MCPB No. 16-122
Sketch Plan No. 320170030
The Claiborne
Date of Hearing: November 10, 2016

RESOLUTION

THE CLAIBORNE # 120170250
FOR
4820 AUBURN, LLC
LOCATION OF SITE
4820 AUBURN AVENUE,
BETHESDA, MD 20814
MONTGOMERY COUNTY
WSSC GRID: 210NW05
TAX MAP # HN23

RE: Preliminary Plan No. 120170250
The Claiborne

SITE
PLAN

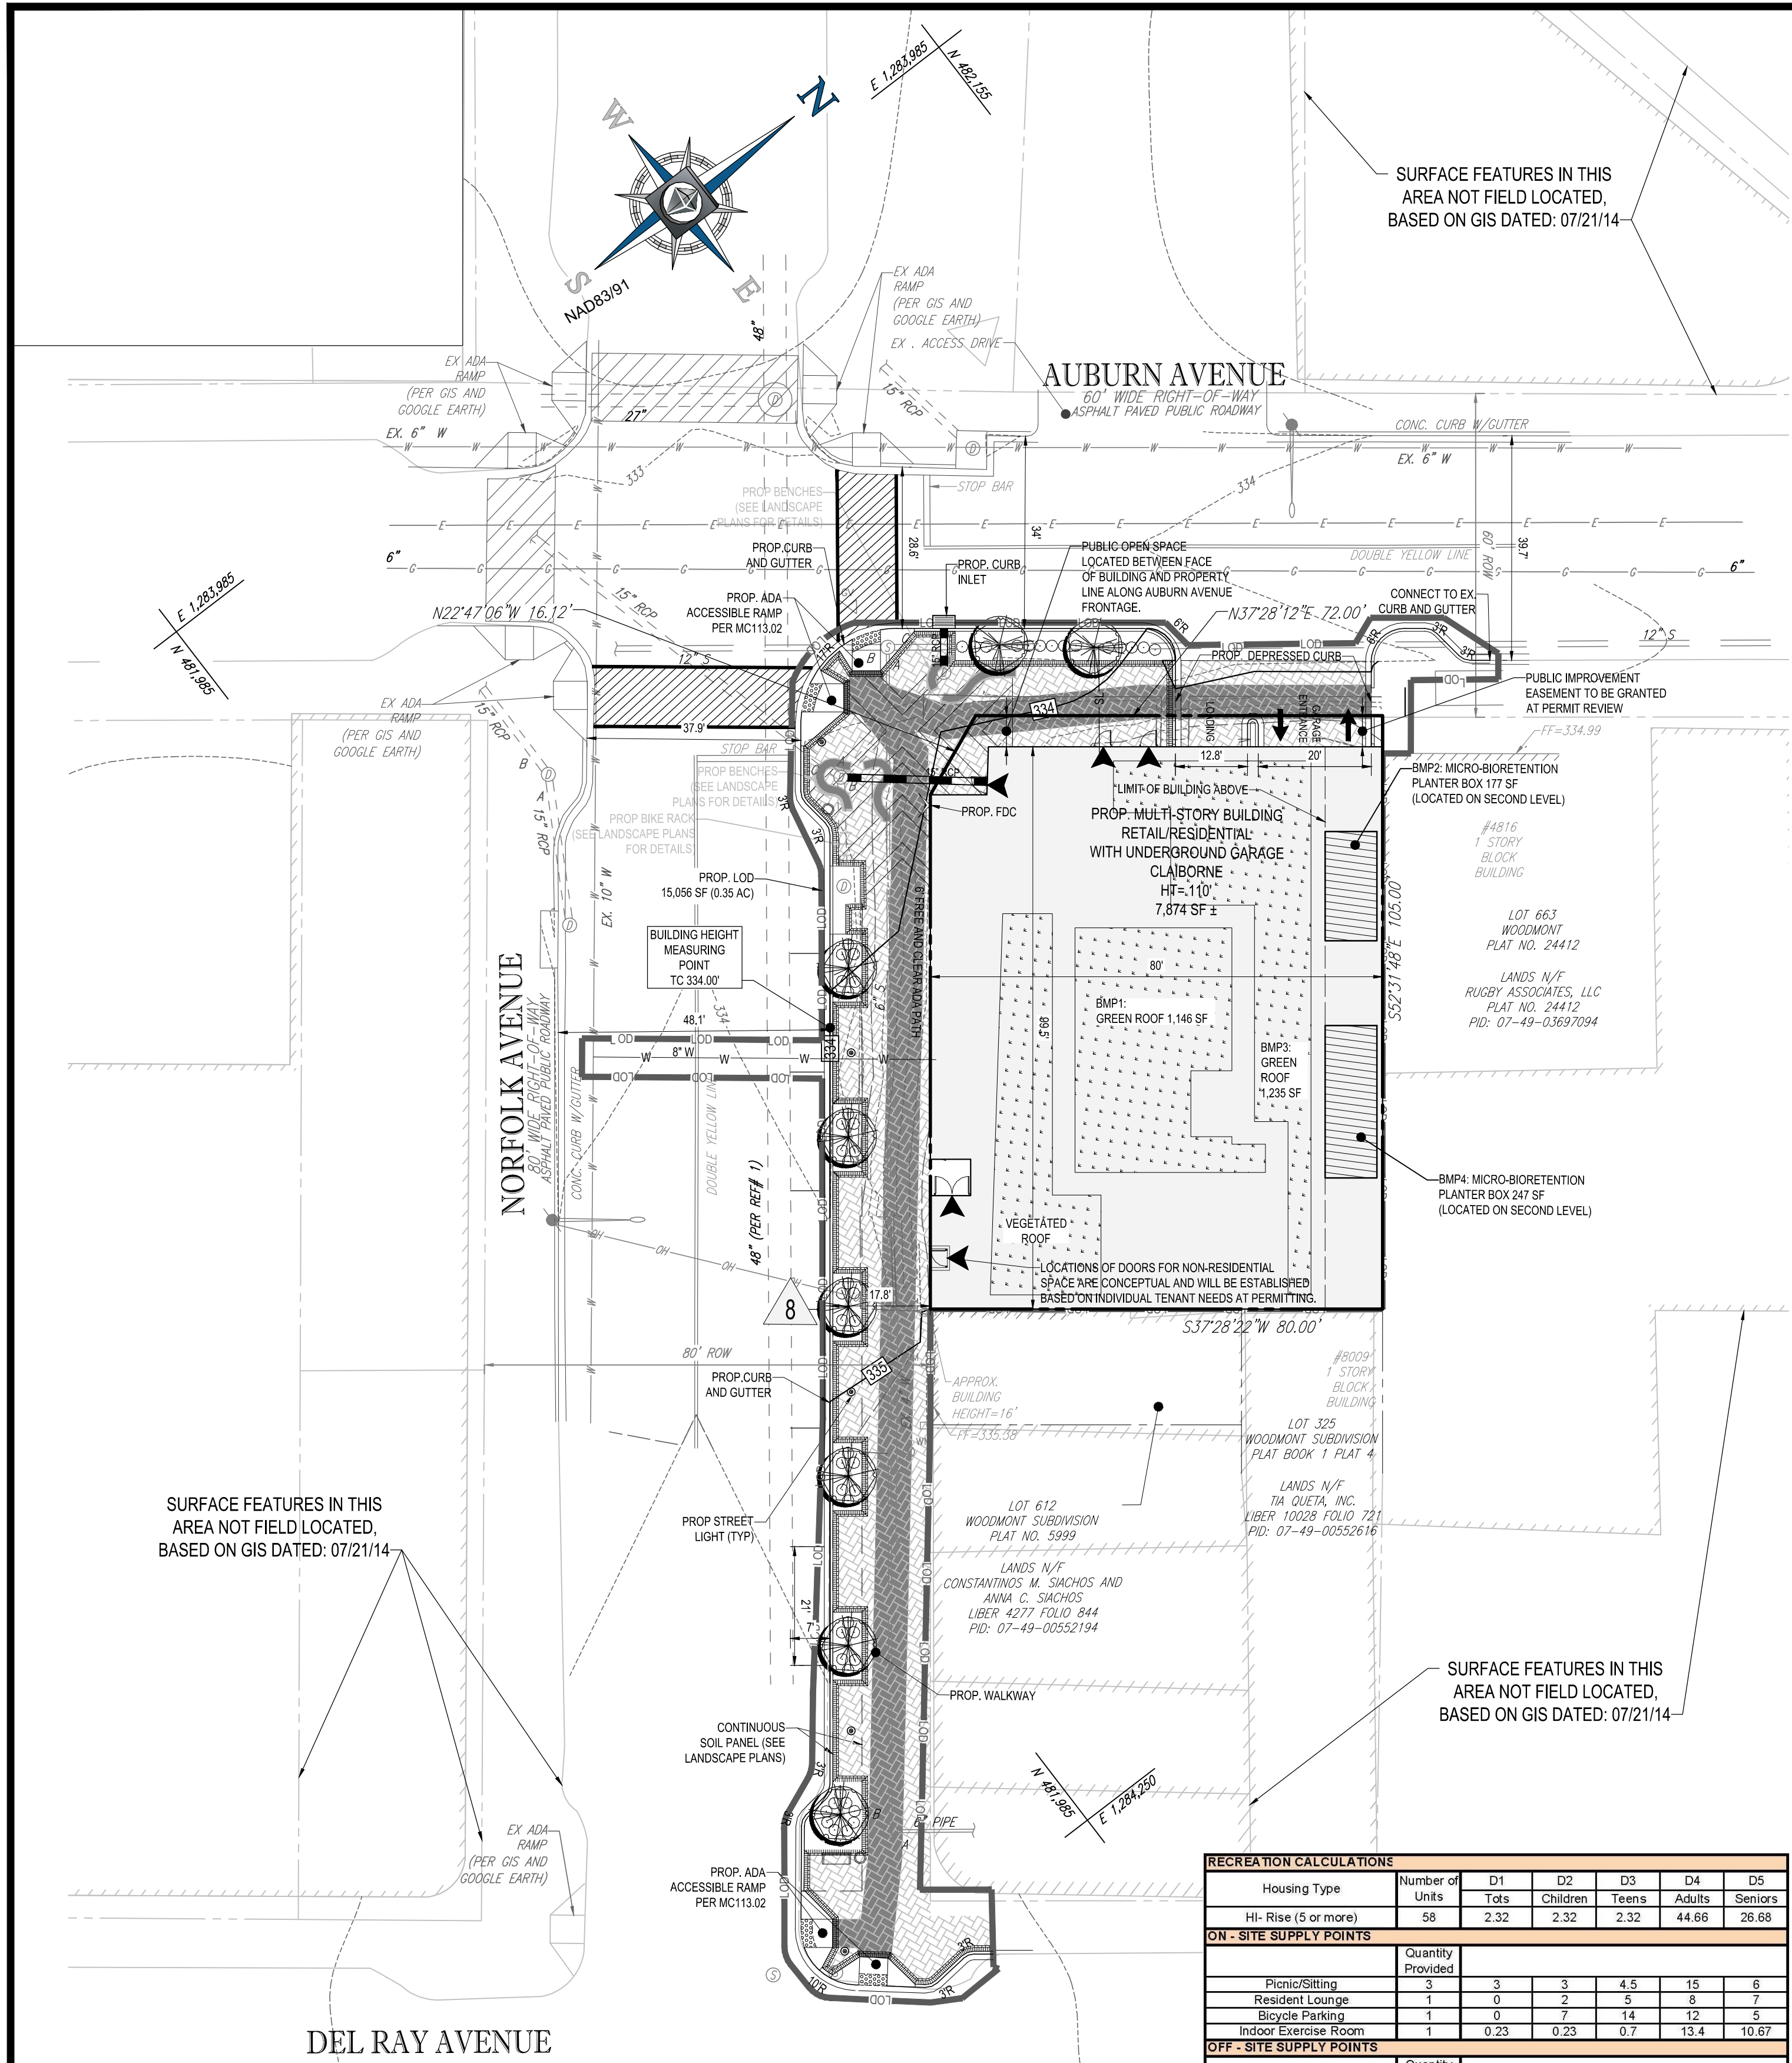
We have completed our review of the preliminary plan dated May 2, 2017. A previous plan was reviewed by the Development Review Committee at its meeting on April 18, 2017. We recommend approval of the plan subject to the following comments:

3. Curb radii for intersection type driveways should be sufficient to accommodate the turning movements of the largest vehicle expected to frequent the site. We accept the consultant's proposal to provide a seventeen (17) foot curb return at the Norfolk Avenue and Auburn Avenue intersection.

4. The storm drain analysis was reviewed and is acceptable to MCDOT. No improvements are needed to the downstream public storm drain system for this plan.

5. The sight distance study has been accepted. A copy of the accepted Sight Distance Evaluation certification form is enclosed for your information and reference. At the permit stage, provide written verification that the adjacent property owner has been apprised of the proposed driveway location and apron curb return limits.
